Date: 14 February 2023

The tables below have been prepared to provide responses to the consultation comments received during the re-consultation exercise (16 Dec 22– 14 Jan 23) on the substitution documents, drawings and responses submitted pursuant to the Former Stag Brewery Redevelopment applications (refs: 22/0900/OUT and 22/0902/FUL).

Application A (ref: 22/0900/OUT)

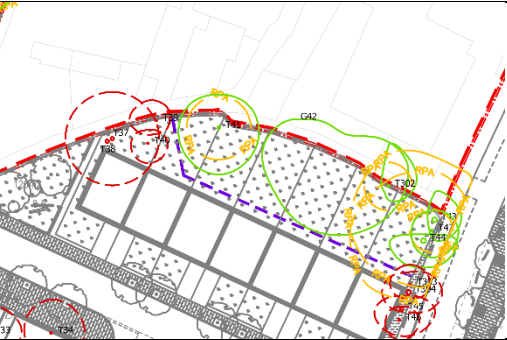
<p><u>Use of the River During Construction</u></p> <p>The Framework Construction Management Statement states at <i>Section 8.1 that consideration has been given to “whether the river could be utilised for logistics, either for removal of spoil associated with the demolition phase or to transport materials associated with</i></p>	Noted, a River Transport Feasibility Study will be undertaken post-determination and secured through a suitably worded planning condition.

Topic	Consultee Comment	Applicant Response (14 February 2023)
	<p><i>the construction phase. A number of significant constraints have been identified in respect of river use, including the highly tidal nature of the river in this location, the significant use of the river in this location (rowing clubs and leisure users) and the poor quality and condition of the wharf and river wall. Notwithstanding this, and subject to securing appropriate permissions and permits, a River Transport Feasibility Study could be carried out to identify whether there is any scope to use the river and overcome the constraints identified.”</i></p> <p>The PLA disagrees with many of the Applicant’s points for example, the River Thames is tidal throughout the entirety of the PLA’s area of jurisdiction and that does not prevent substantial volumes of material being transport by water. However, the PLA does agree to the carrying out of a River Transport Feasibility Study and it is recommended that this is secured through a condition on any grant of planning permission.</p>
